APPEAL SUMMARY

Appeal ID: 24647	Project Address: 6223 SE Clatsop St
Hearing Date: 2/24/21	Appellant Name: Zane Goff
Case No.: B-010	Appellant Phone: 5033359218
Appeal Type: Building	Plans Examiner/Inspector: Wesley Bird
Project Type: residential	Stories: 1 Occupancy: R-3 Construction Type: I-V
Building/Business Name:	Fire Sprinklers: No
Appeal Involves: Alteration of an existing structure, Reconsideration of appeal	LUR or Permit Application No.:
Plan Submitted Option: pdf [File 1]	Proposed use: Residence

Project No. 20-71-7108

Drawing: Floor Plans

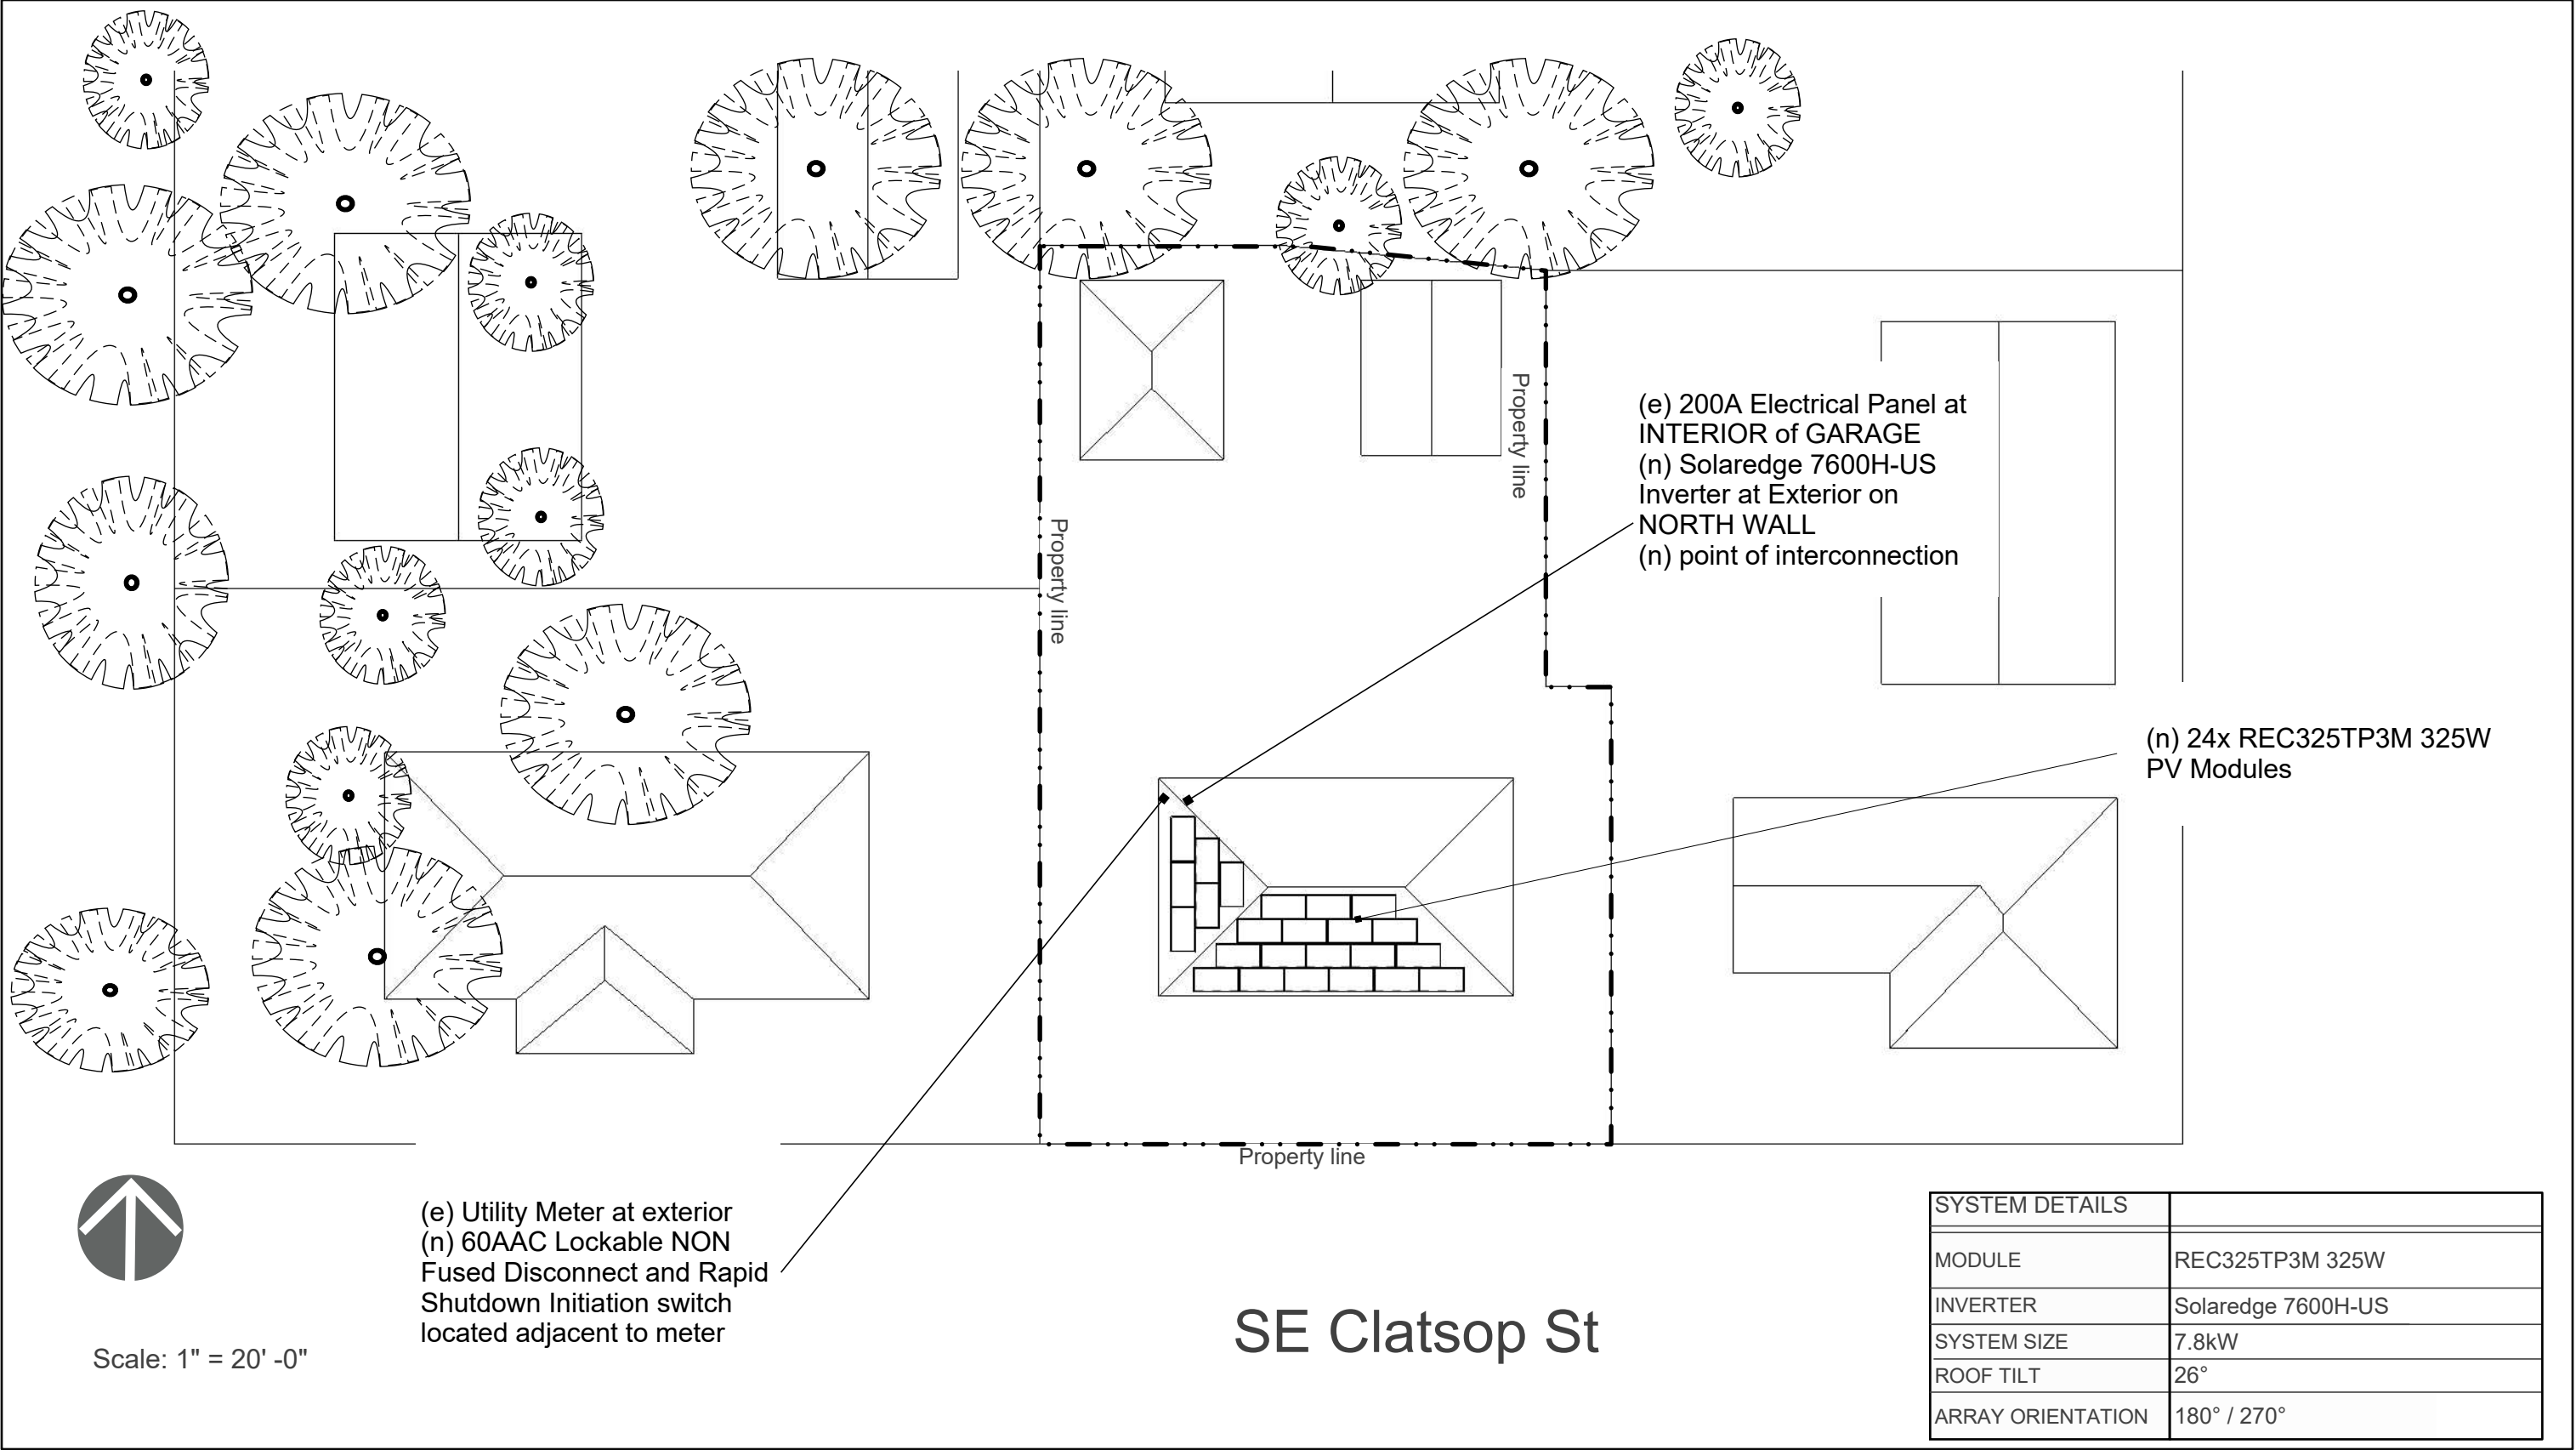
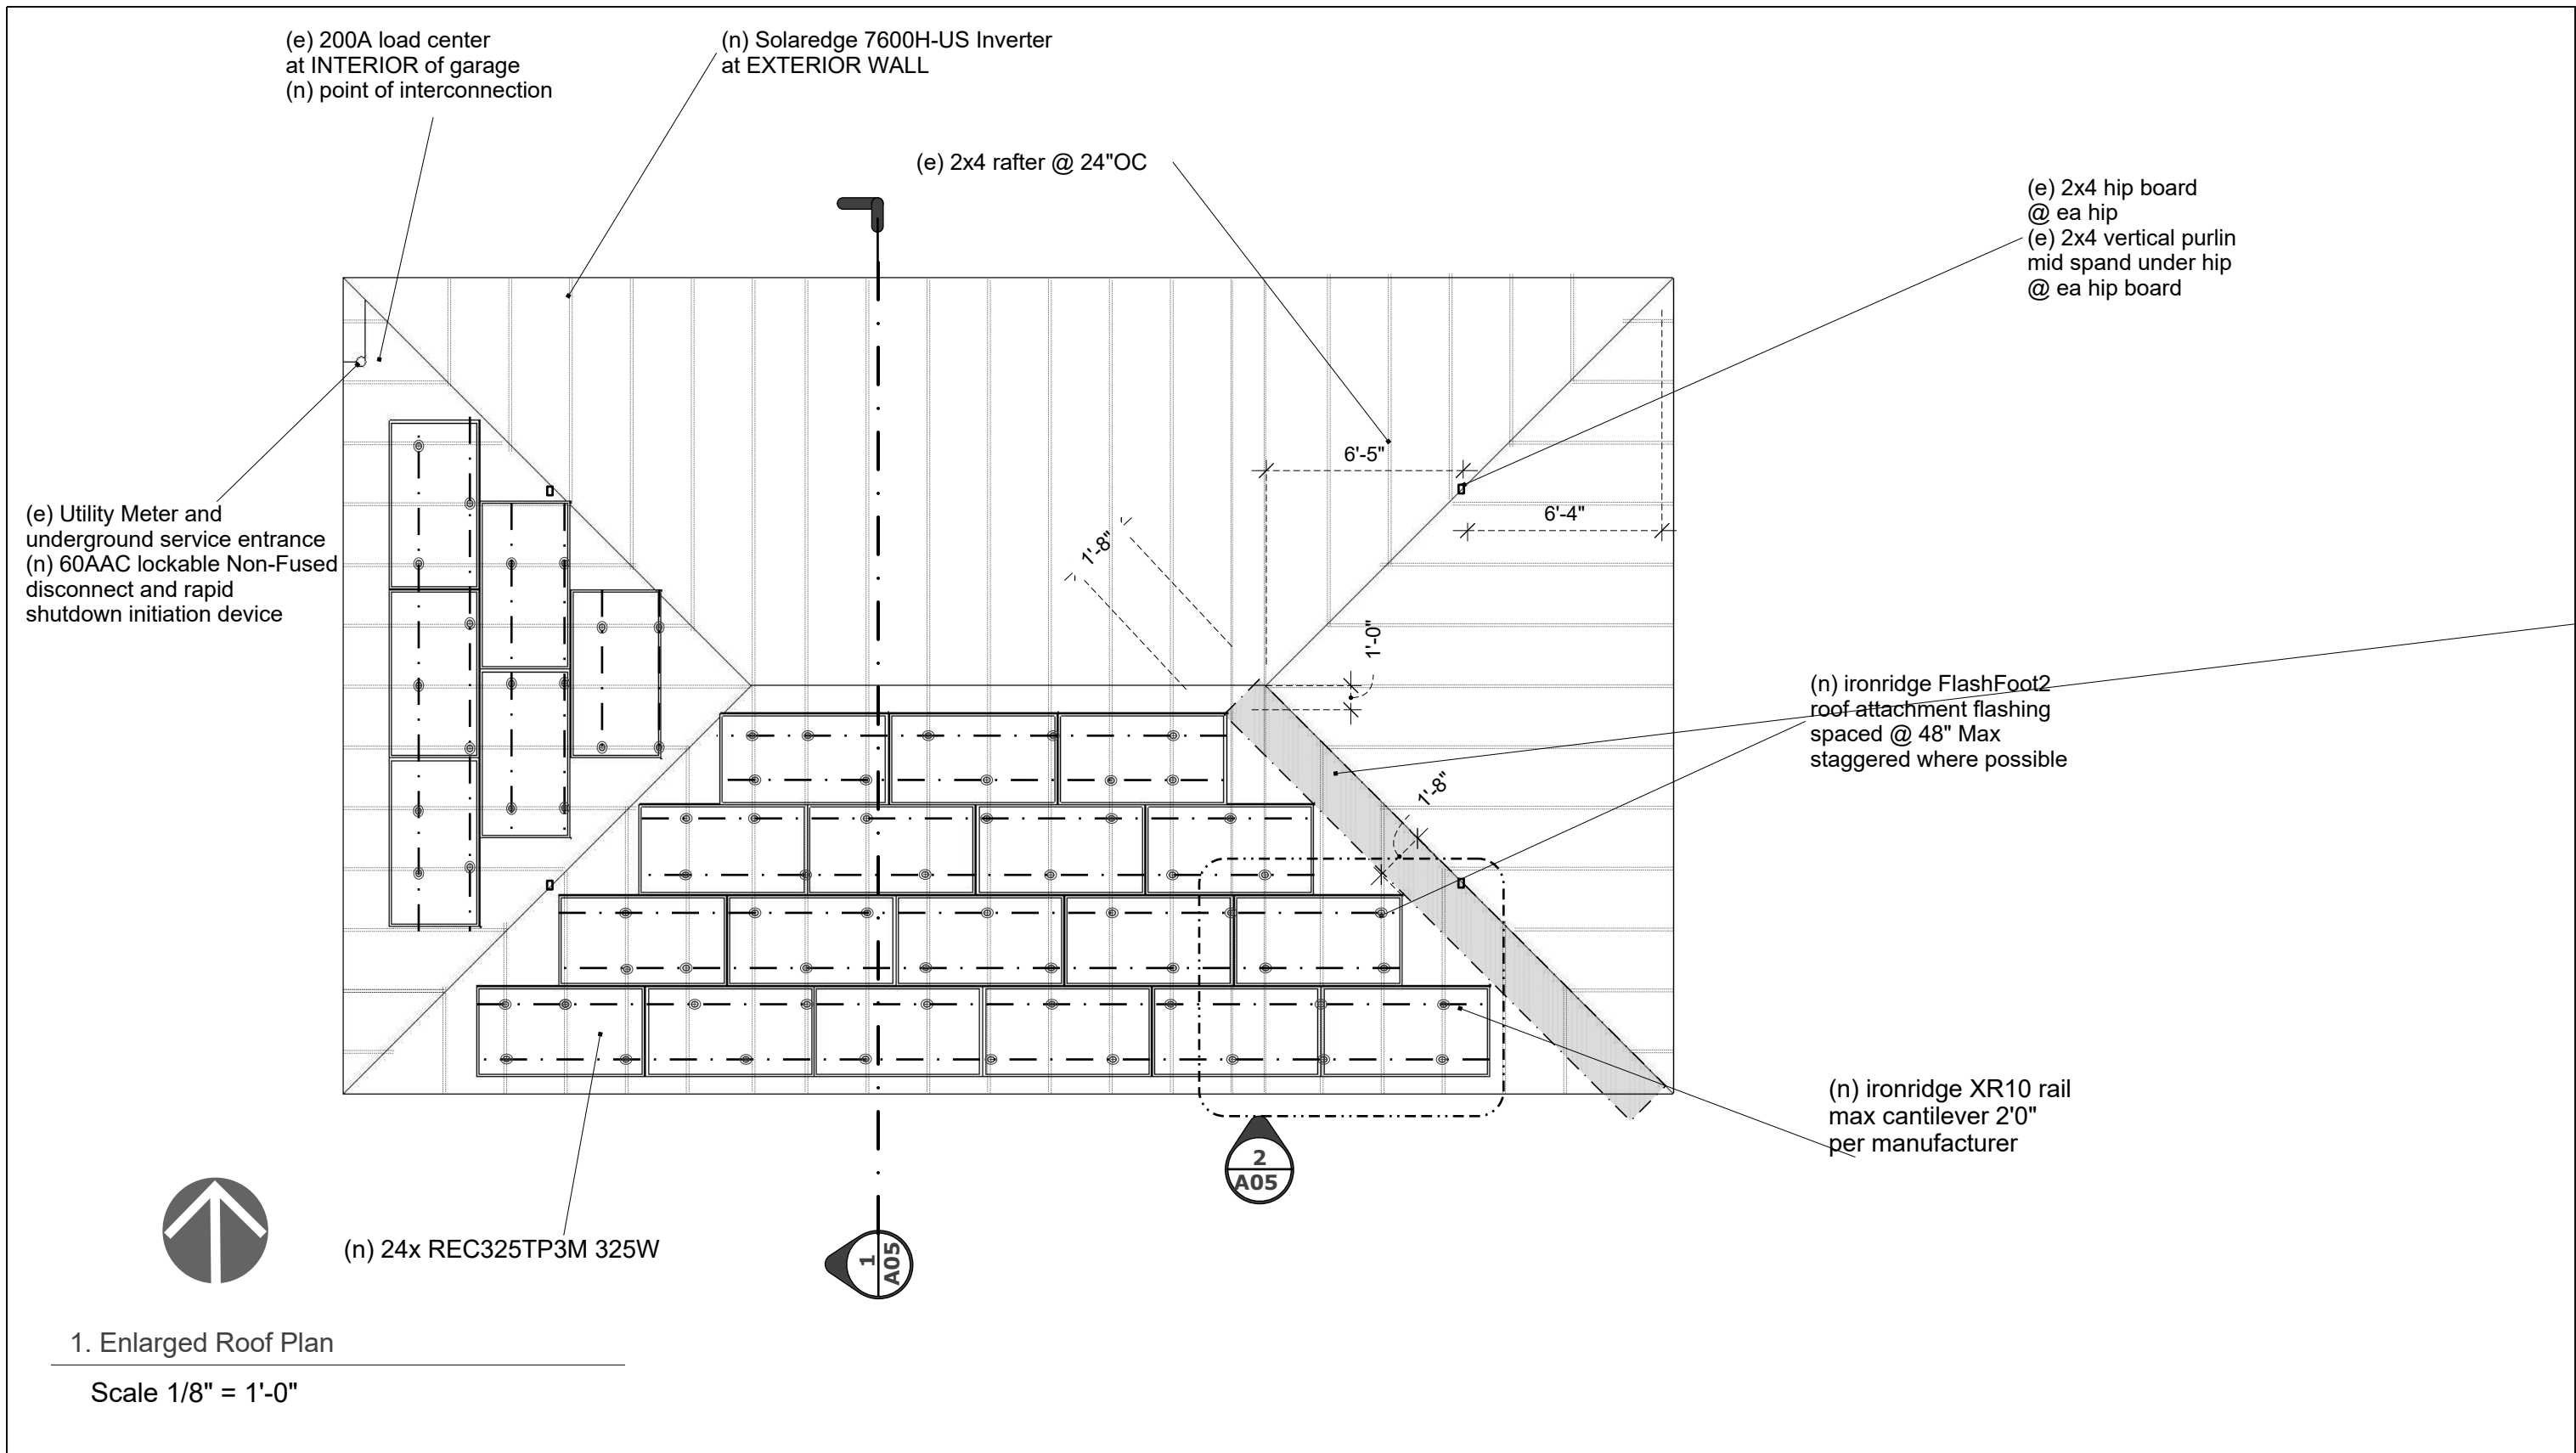
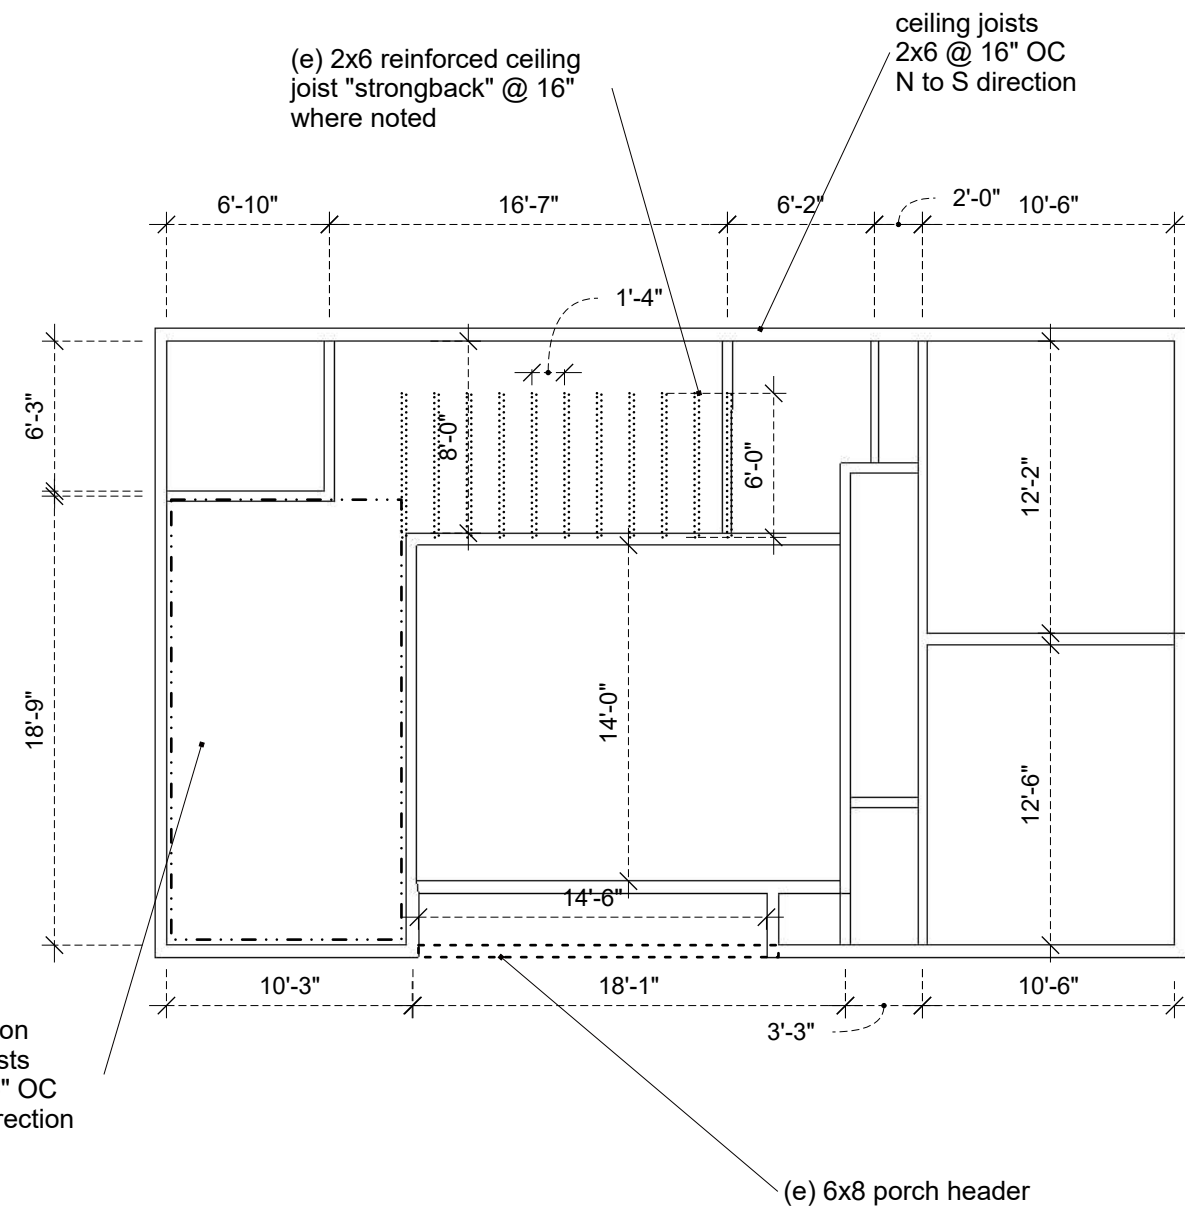
Code Section	OSSC2019 3111.3.4.8.1
Requires	3111.3.4.8.1 PV installations require a 36" pathway along 3 sides of solar roof. Bottom edge not to be used as pathway Exceptions 1.1 Where PV Array does not exceed 25%, 12" pathway at ridge acceptable.
Code Modification or Alternate Requested	PV array exceeds 25% of the roof area and homeowner would like to install an array that offsets all of her energy consumption.
Proposed Design	7.8kW PV array, 25 modules on south and west faces of roof. 12" pathway at ridge to be maintained. 20" pathway to be maintained along dominant solar roof face along East hip of South face of roof.
Reason for alternative	Single story hipped roof allows for easy access for first responders to all 4 sides of the house, so access is not excessively blocked by PV array. THIS IS A NO FEE RECONSIDERATION. DISTANCE FROM HIP INDICATED ON PLANS.

Roof Type: Composition Asphalt
Age: <1 years Layers: 1
Roof Framing: 2x4 DF Rafters @ 24" OC
Roof Tilt: 26° Array Azimuth: 180° / 270°
Area of Roof: 1303.4sq ft
Area of PV Array: 437.4sq ft
Array= 33.5% of roof area
36" Pathway REQUIRED per OSSC2019 3111.3.4.8.1
EXCEPTION TO PATHWAY REQUIREMENTS REQUESTED

Increase in 25 percent maximum allowable area of solar photo voltaic array with omission of 36 inch pathways: Denied. Proposal does not provide equivalent Life Safety protection.
